### 976-2016 ADDENDUM 4

SOUTH END SEWAGE TREATMENT PLANT (SEWPCC) UPGRADING / EXPANSION PROJECT - CONTRACT 4 – SITEWIDE MECHANICAL, ELECTRICAL, CONCRETE AND SITE WORKS

ISSUED: July 07, 2017

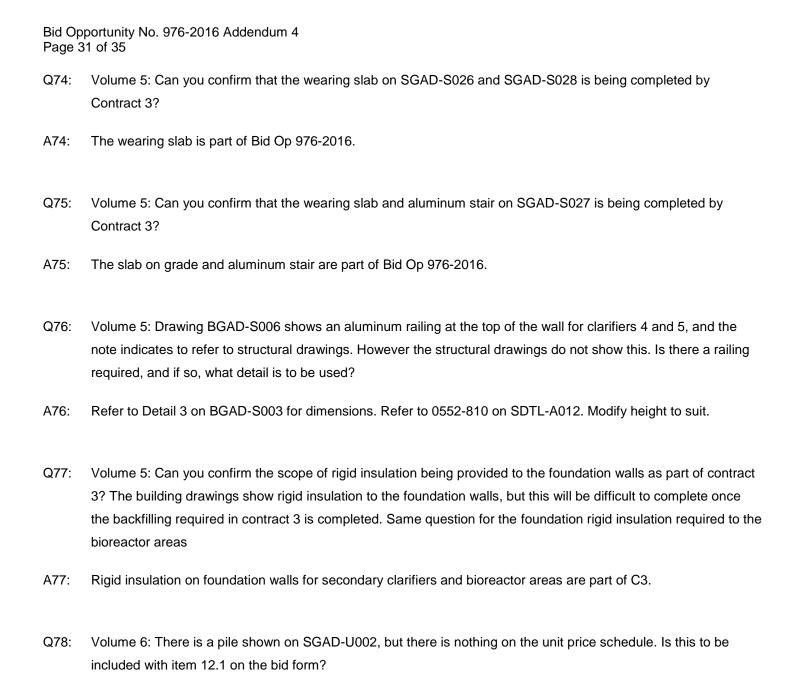
Q71: Volume 5: Can you confirm that the wall mounted aluminum handrail shown on stair 1 on drawing SGAD-S014 is being completed by Contract 3?

A71: The handrail shown is part of Bid Op 976-2016.
